ADDENDUM

Project:	4th & Main Park 400 Main Street Evansville, IN 47708	Addendum No.:	002
		Date:	September 24, 2025
Owner:	Evansville Parks and Recreation 100 E Walnut Street Evansville, IN 47713	Project Number:	2404-183
		Contract for:	General

The original specifications and drawings dated September, 2025 for the project noted above are amended as noted in this Addendum Number 002. Receipt of this addendum and any subsequent addenda must be acknowledged on the final bid documents. This addendum consists of 5 item(s) and attachment(s).

LA103

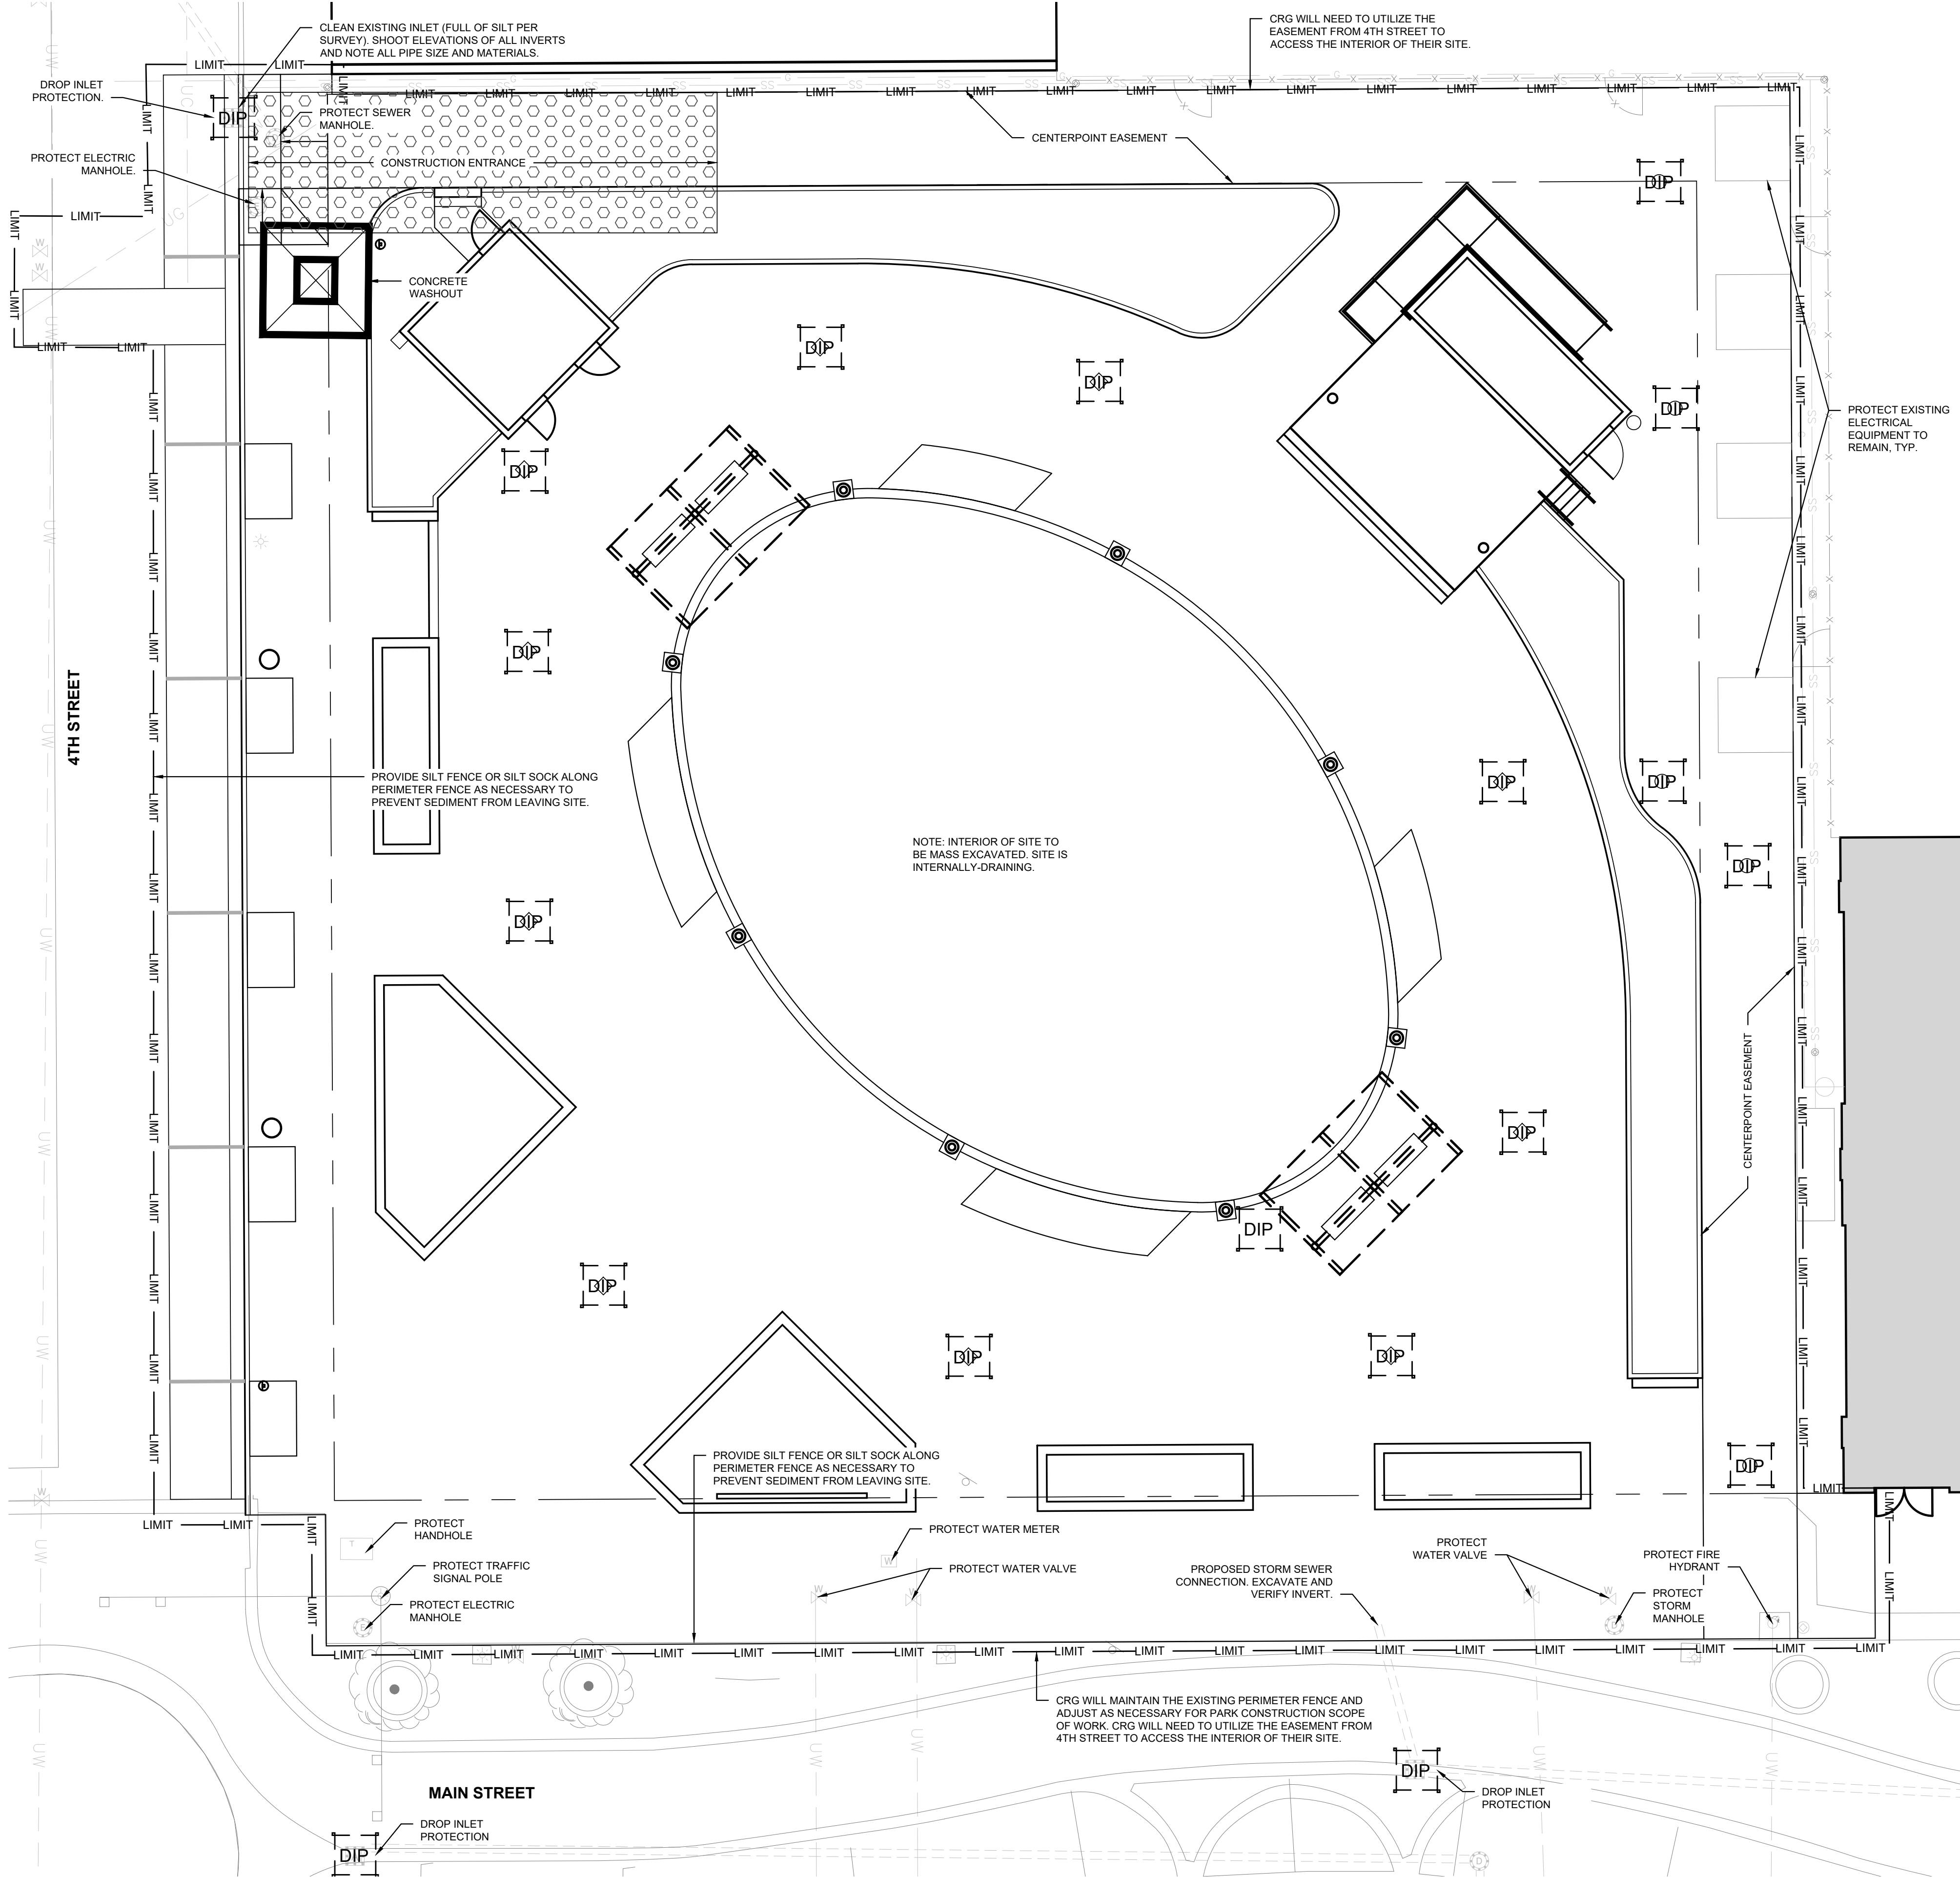
1. Drawing sheet LA103, EROSION CONTROL PLAN: Add new drawing sheet LA103, EROSION CONTROL PLAN, attached to this Addendum.
2. Drawing sheet U101, SITE UTILITIES PLAN: Delete Drawing Sheet U101 in its entirety and replace with new drawing sheet U101, SITE UTILITIES PLAN, attached to this Addendum.
3. Drawing sheet U201, SITE UTILITY DETAILS: Delete Drawing Sheet U201 in its entirety and replace with new drawing sheet U201, SITE UTILITY DETAILS, attached to this Addendum.
4. Drawing sheet P1.2, FIRST FLOOR PLUMBING PLAN: Delete Drawing Sheet P1.2 in its entirety and replace with new drawing sheet P1.2, FIRST FLOOR PLUMBING PLAN, attached to this Addendum.
5. Drawing sheet P2.1, PLUMBING DETAILS AND SCHEDULES: Delete Drawing Sheet P2.1 in its entirety and replace with new drawing sheet P2.1, PLUMBING DETAILS AND SCHEDULES, attached to this Addendum.
